RE: Restaurant
Site Plan and Architectural revisions
146 East Main Street

As requested, the following is a list of changes from the site plan package approved by the Planning Board on December 8, 2020 and conditions that were subsequently constructed/ installed at the site.

PROPOSED
EXTERIOR VIEWS -
WHITE SIDING

DRAWING TITLE: PARKING LOT MODIFICATION SKETCH		
SCALE: AS NOTED	DATE ISSUED: 03-29-22	PROJECT No.: 2019.034
DRAWN BY: GP	CHECKED BY: RZ	APPROVED BY: JZ
ZARECKI & ASSOCIATES, L.L.C. Consulting Engineers - Land Surveyors - Architects 11 West Main St. Pawling, NY 12564 845.855.3771 845.855.3772 (Fax)		DWG. NO. SK-1
		SHEET 01 OF 01

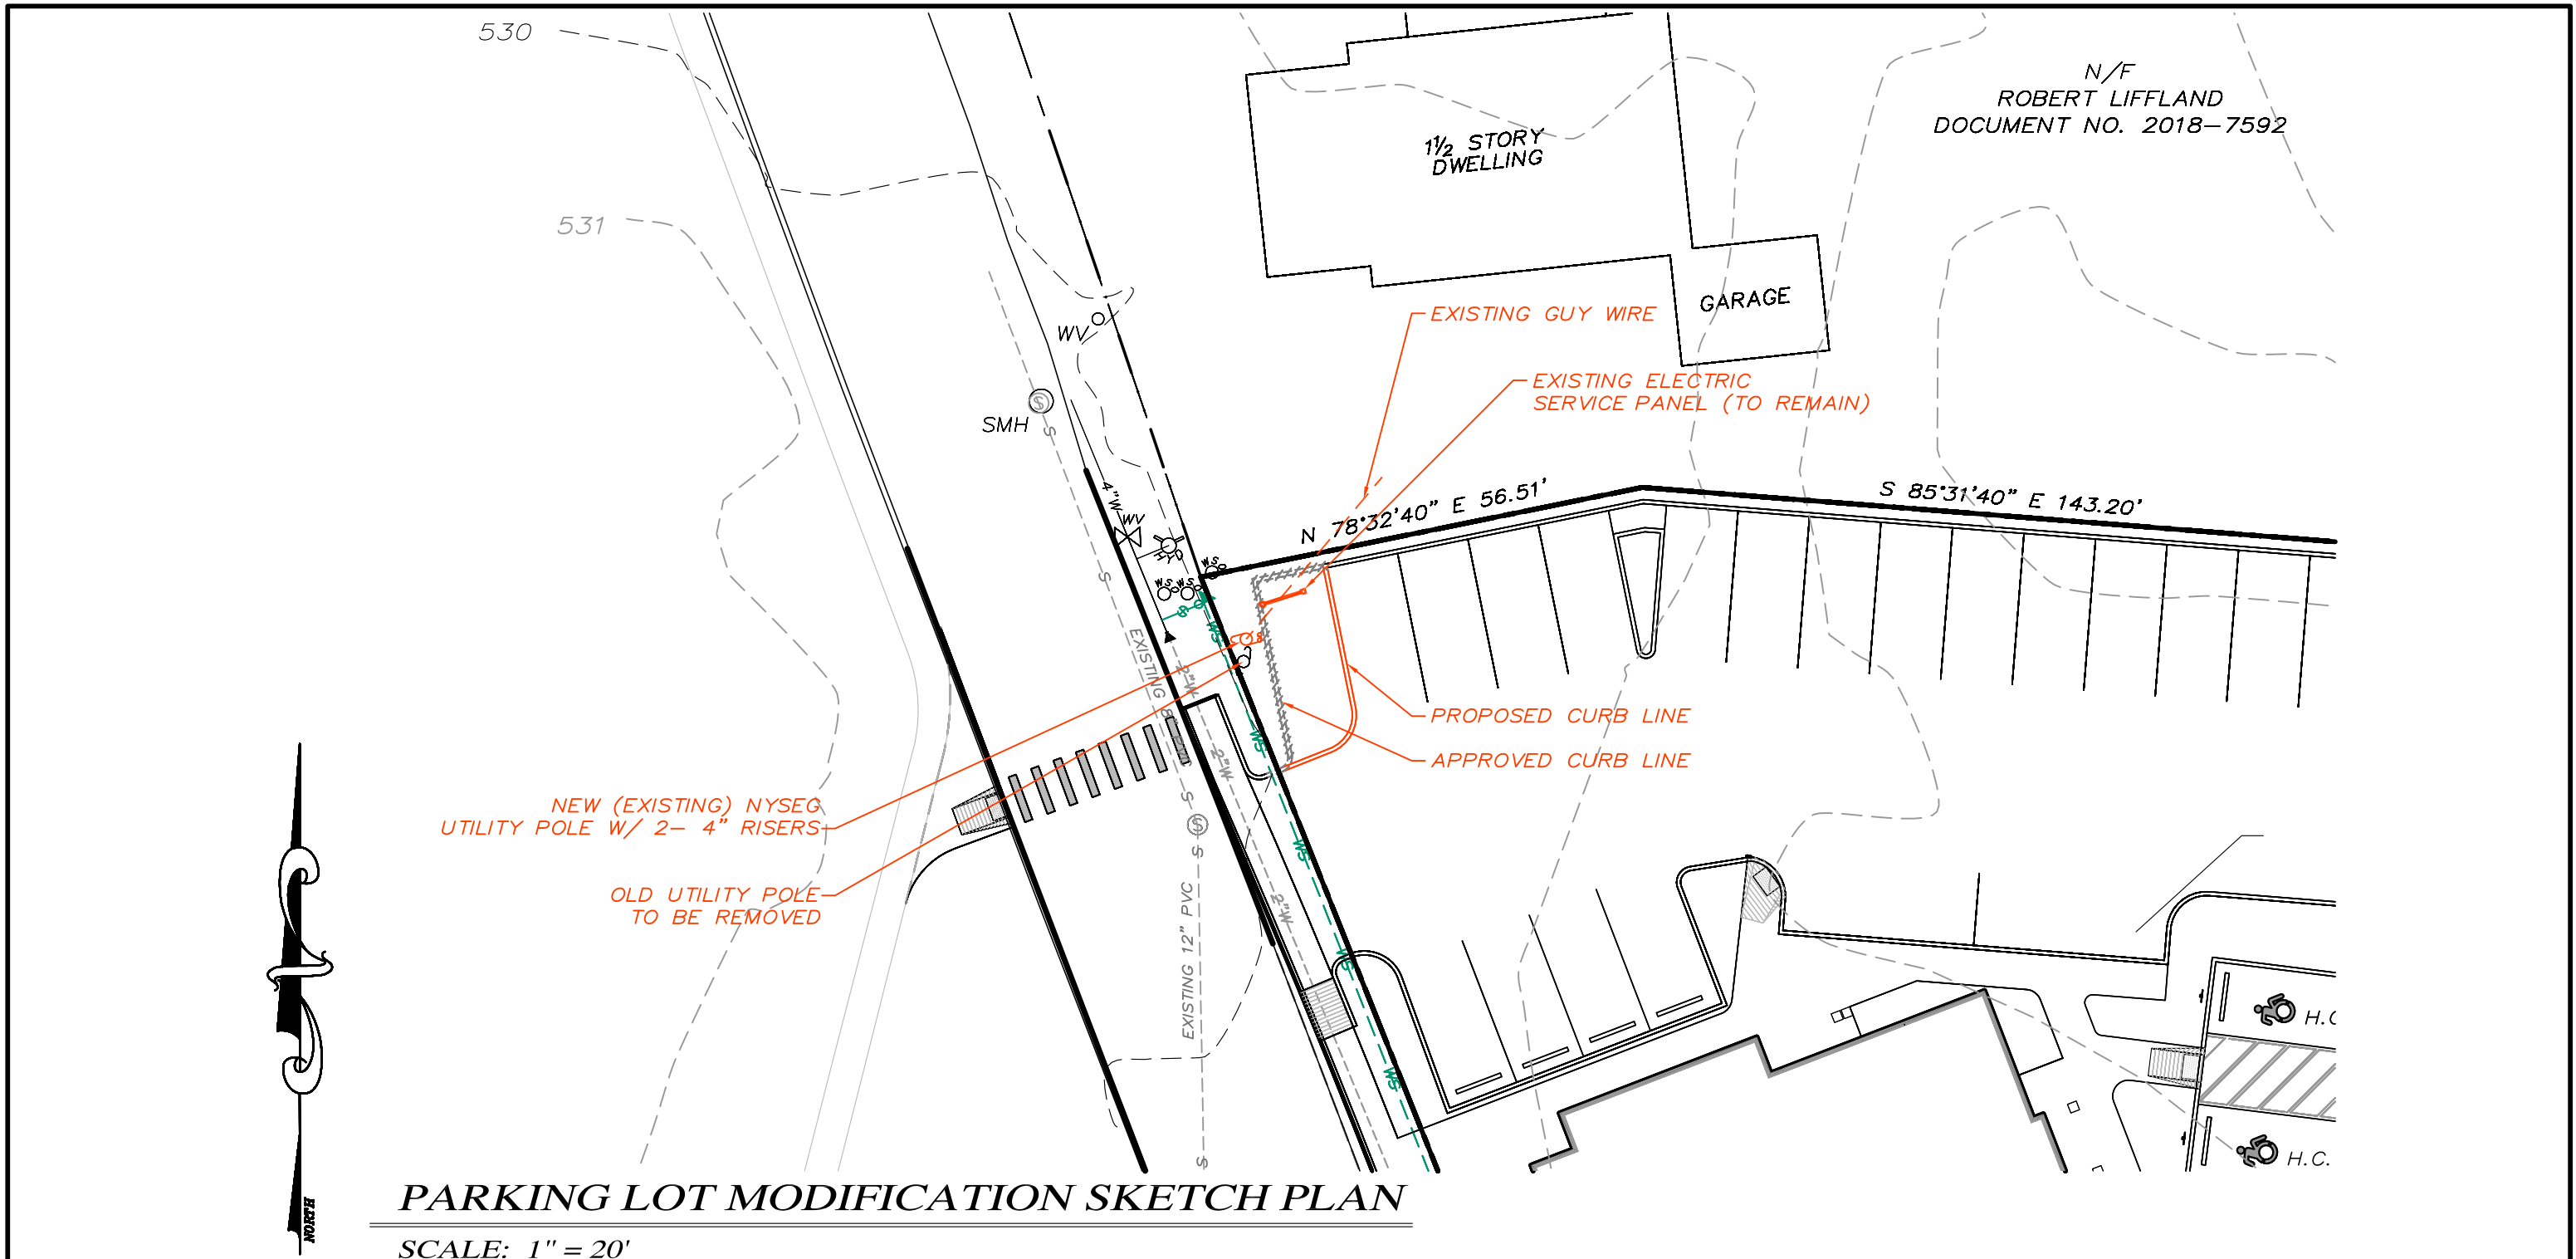
- Although the original site plan/architectural approval included natural stone veneer, supply chain shortages during construction necessitated use of an alternate material. Brick veneer was selected due to availability and that the Planning Board approved the alternate material in deliberation in the Fall of 2021. There are several examples of brick architecture throughout the Village, particularly in the downtown 'core'. While people pass the NYS Route 22 and East Main Street intersection, the use of the brick on the subject building may be perceived as a 'marker' indication of what is found in the Village 'core'. The solid feel and scale of the building also creates a sense of entry into the Village. The Comprehensive Plan for the Village did suggest installation of pylons at the four corners of the NYSDOT ROW at the East Main Street intersection. Although this was a very conceptual idea and would have much difficulty coming to fruition for various reasons (cemetery, sightlines, road ownership, etc.), the restaurant structure and associated freestanding signage may satisfy one of the corners of the conceptual 'pylons' at the intersection.

- The brick-faced half wall on the second-floor dining area will be removed and replaced with a painted metal and/or composite railing system per the approved plans. The railing will match the style of railing systems at the main entry roof covering as well as the railing that will surround the rooftop HVAC units on the north side of the building.

It is proposed to install an additional decorative column adjacent to each existing column along the ground-level outdoor dining area. Base and capital trim pieces shall be added to the columns. The cross-sectional shape of the columns shall be square to match the column enclosures already installed. Decorative columns with brick bases shall be placed at the main/east side entry per the approved design drawings.

- It is proposed to cover some of the brick at south and east sides (main entry and south end of main dining area) of the building with a composite/PVC trim to better attain the design intent of the approved plans. The color of the trim shall be white. Existing corner boards on upper story to remain.

- It is proposed to remove the cultured stone on the second story (north end of outdoor dining area) and replace with composite horizontal lap siding to match existing second-story walls. The cultured stone on the lower-level outdoor dining area will be removed and replaced with travertine tile to match the adjacent wall. The travertine wall finish on the second floor shall remain.

- In addition to the items mentioned above, further discussion on the final color of the Hardieboard siding is offered. The Board may feel that a tone-on-tone (trim and siding) white color may work better in place of the beige color that is currently on the building. The owner is open to discussing this further.

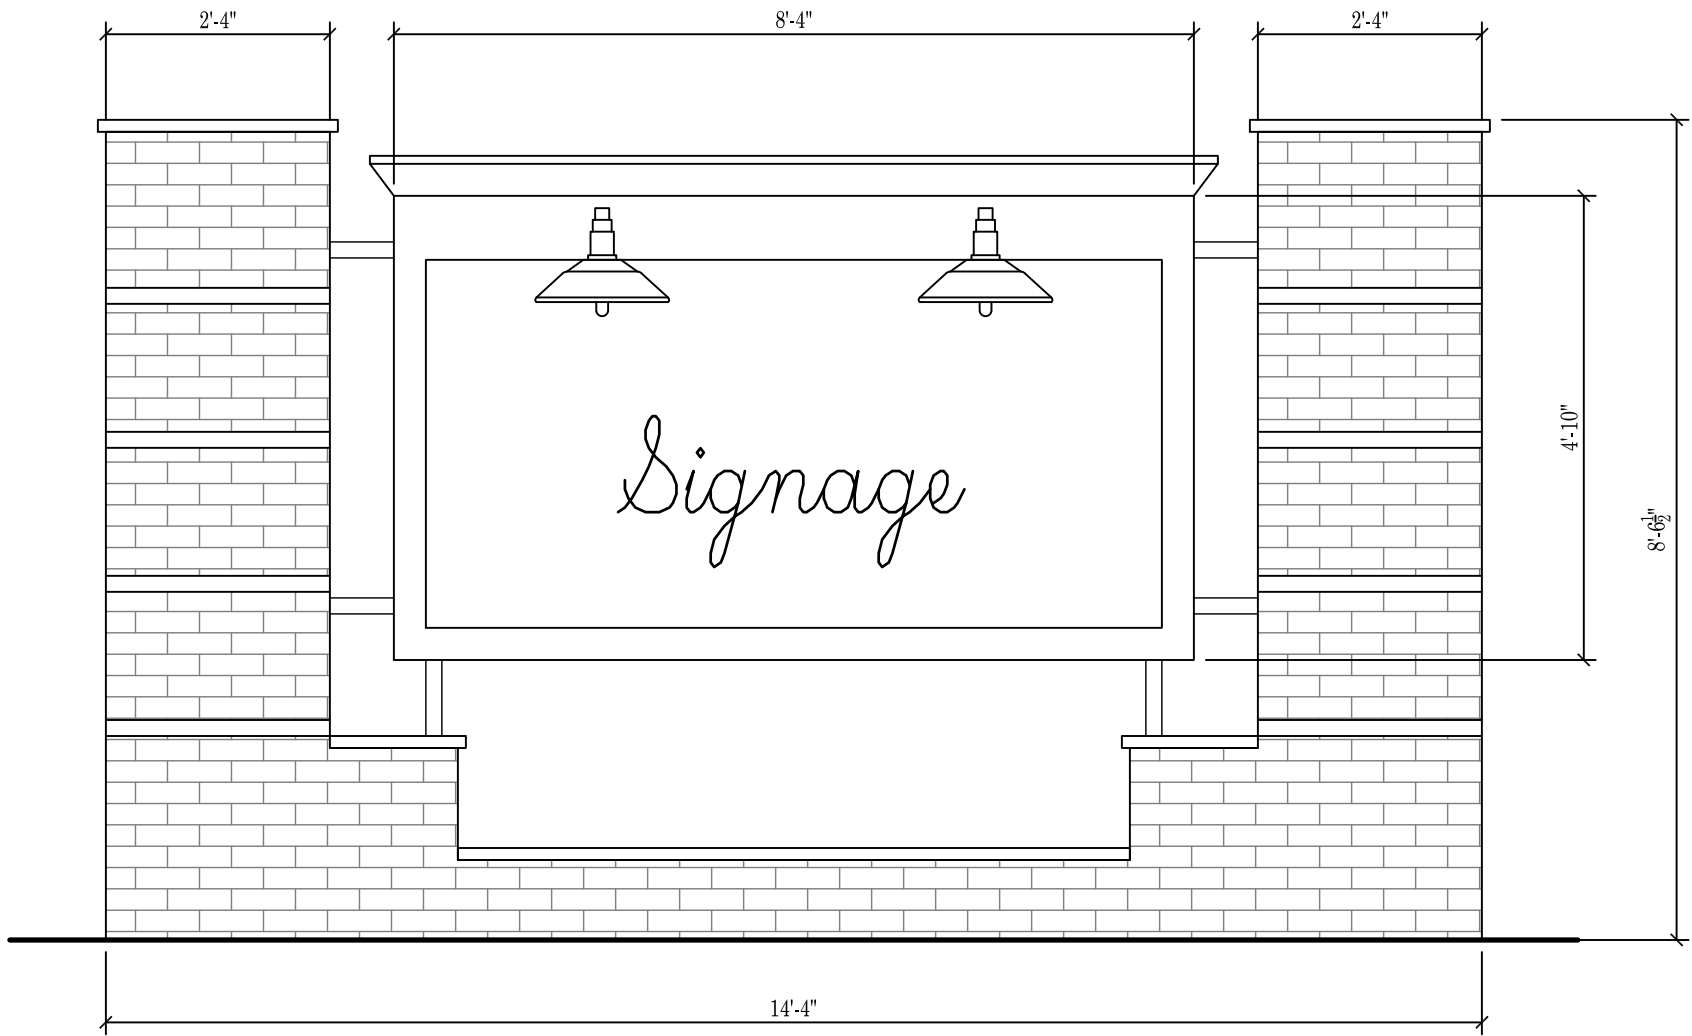
- NYSEG has installed a new pole and permanent electrical service/meter panel for the restaurant. The location (as dictated by NYSEG) of these items will require the elimination of one parking spot at the northwest corner of the site. This area will now become green space, curbing shall be modified and meter panel will be painted and screened with some plantings.

41 parking spaces were approved previously. The elimination of the aforementioned parking space will result in a total of 40 parking spaces on the site.

- Vegetative screening for north end of parking area has been added to the site plan. As this planting is proposed to be installed on the 140 East Main Street site (under similar/related ownership), an easement will be required for installation and maintenance.

SIGNAGE FRONT VIEW

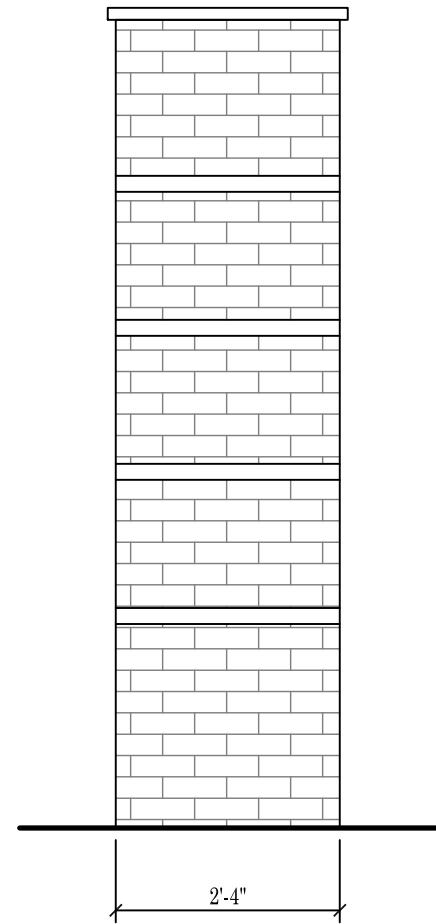
- The sign detail has been revised and is included in this submission. The sign is in the same general location as previously approved.
- The installed Belgian block curbing within the Village ROW along East Main Street shall be removed and replaced with poured-in-place concrete curbing. The curbing within
